Issue List

NCANG Repair Bldg 51 (Charlotte, NC)

Project Issue Information

Issue Name : EF-15 Not Operational

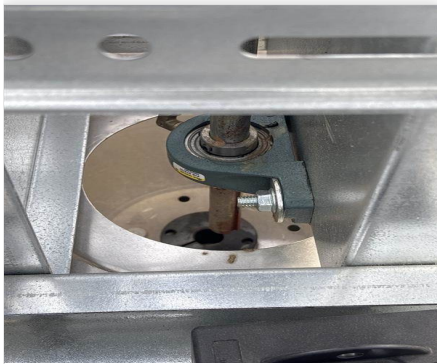
Description : EF-15 shaft to the blower is not connected at this time.

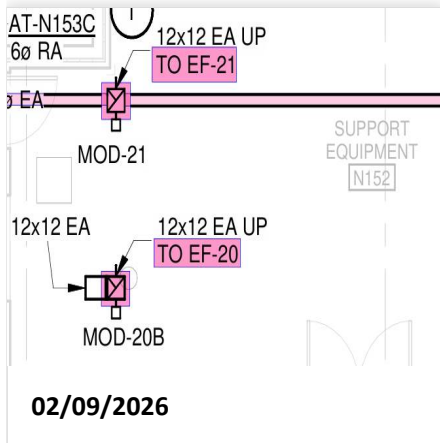
Issue Name : EF-20 and EF-21 Ductwork swapped
Description : According to the drawings, EF-21 and EF-20 ductwork have been swapped, but the fans were not. According to the submittal, EF-21 GB-097-6 is rated for max 275 CFM and is unable to satisfy 900 CFM.
Created By : National TAB **Assigned To :** National TAB - Antonio Flores-De La Cruz
Status : Open
Priority : Urgent **Asset Tag :**
Originated Date : 02/09/2026 - Antonio Flores-De La Cruz - National TAB

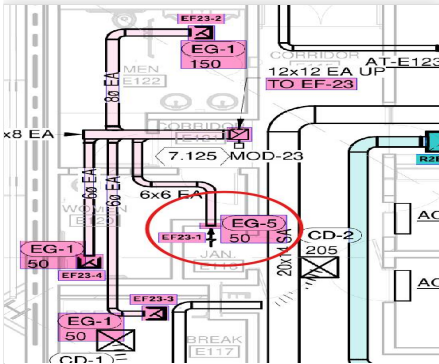
Issue Name : EF-23 High Flow
Description : EF-23 is 37% above design (407 CFM ACTUAL / 300 CFM DESIGN) and requires a sheave change to reduce flow. Motor sheave is on the lowest setting. Unable to balance due to a diffuser missing as well.
Created By : National TAB **Assigned To :** National TAB - Antonio Flores-De La Cruz
Status : Open
Priority : Urgent **Asset Tag :**
Originated Date : 02/12/2026 - Antonio Flores-De La Cruz - National TAB

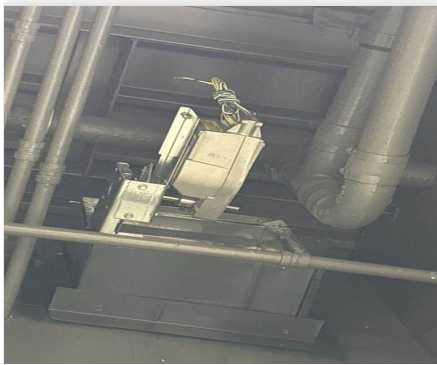
Issue Name : EF-26 Low Flow
Description : EF-26 is at 66% of design (99 CFM ACTUAL / 150 CFM DESIGN). The speed dial is at max. A possible cause could be a partially opened exhaust motorized damper. It was found that there is a damper at the takeoff and one at the arm of the equipment where the duct connects, which may add resistance to the system.

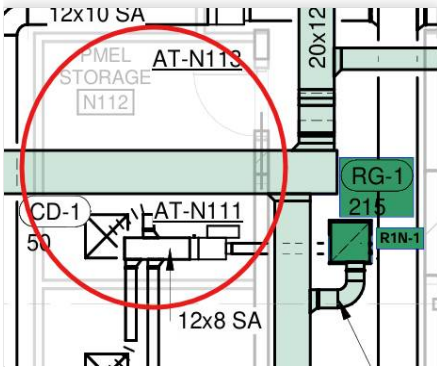
Issue Name : ERV-1 Missing Return Dampers
Description : ERV-1 has no dampers installed to balance the return. Total flow was set.
Created By : National TAB **Assigned To :** National TAB - Antonio Flores-De La Cruz
Status : Open
Priority : Urgent **Asset Tag :**
Originated Date : 02/10/2026 - Antonio Flores-De La Cruz - National TAB

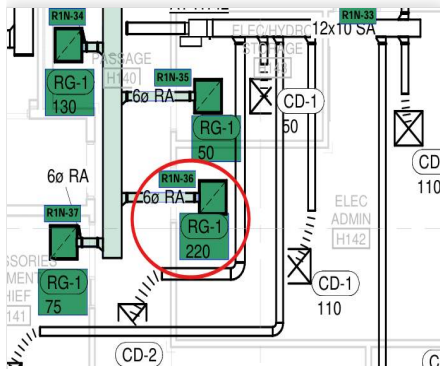
Issue Name : Hanger EFs Not Operational
Description : EF-9 through EF-19, EXCEPT EF-13, are not operational. Controls stated the exhaust fans might be wired incorrectly. Further investigation is required.
Created By : National TAB **Assigned To :** National TAB - Antonio Flores-De La Cruz
Status : Open
Priority : Urgent **Asset Tag :**
Originated Date : 02/12/2026 - Antonio Flores-De La Cruz - National TAB

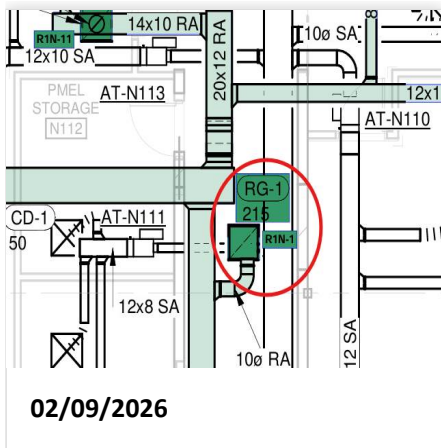
Issue Name : PAH-1 Not Operational
Description : After speaking to Controls, they stated that PAH-1 is not operational. Also, when the unit becomes operational, assistance is needed to enter the communications room, as a sign on the door states that entry is prohibited without prior approval from NCANG.
Created By : National TAB **Assigned To :** National TAB - Antonio Flores-De La Cruz
Status : Open
Priority : Urgent **Asset Tag :**
Originated Date : 02/12/2026 - Antonio Flores-De La Cruz - National TAB

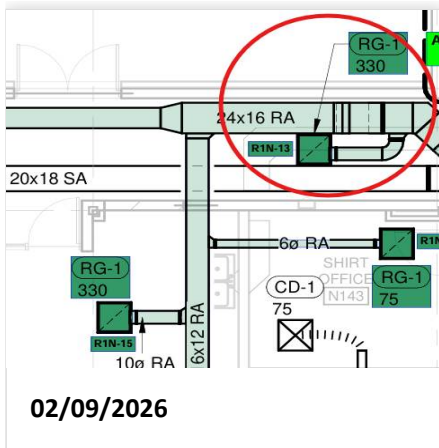
Issue Name : Return Grille for AHUN1 Not installed
Description : Grille R1N-1 in CORRIDOR N107, not installed.
Created By : National TAB **Assigned To :** National TAB - Antonio Flores-De La Cruz
Status : Open
Priority : **Urgent** **Asset Tag :**
Originated Date : 02/09/2026 - Antonio Flores-De La Cruz - National TAB

- **02/12/2026 National TAB - Antonio Flores-De La Cruz**
 - Grille Installed

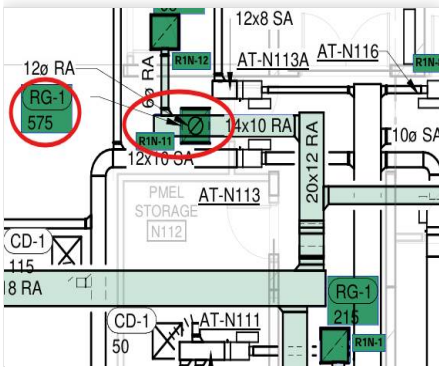
Issue Name : Return Grille not installed in CORRIDOR N150
Description : Return Grille R1N-15 not installed in CORRIDOR N150.
Created By : National TAB **Assigned To :** National TAB - Antonio Flores-De La Cruz
Status : Open
Priority : Urgent **Asset Tag :**
Originated Date : 02/09/2026 - Antonio Flores-De La Cruz - National TAB

- **02/12/2026 National TAB - Antonio Flores-De La Cruz**
 - Grille Inserted

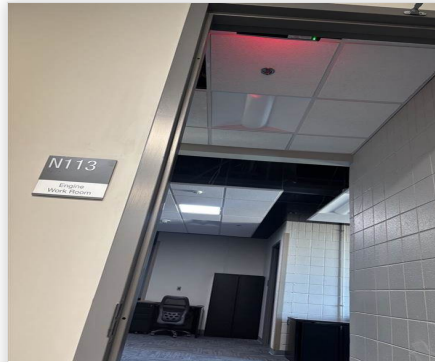
Issue Name : Return Grille not installed in ENGINE WORKROOM N113
Description : Return grille R1N-11 not installed in ENGINE WORKROOM N113.
Created By : National TAB **Assigned To :** National TAB - Antonio Flores-De La Cruz
Status : Open
Priority : **Urgent** **Asset Tag :**
Originated Date : 02/09/2026 - Antonio Flores-De La Cruz - National TAB

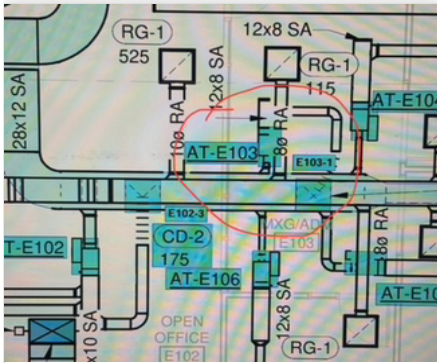
Issue Name : VAV AT-E103 Wrong Location
Description : VAV AT-E103 is installed in the wrong location per the drawings. It should have been installed in MXG/ADM E103 but instead was installed in room OPEN OFFICE E102. A diffuser is installed in room E103, but it is connected to VAV AT-E101, which is incorrect.
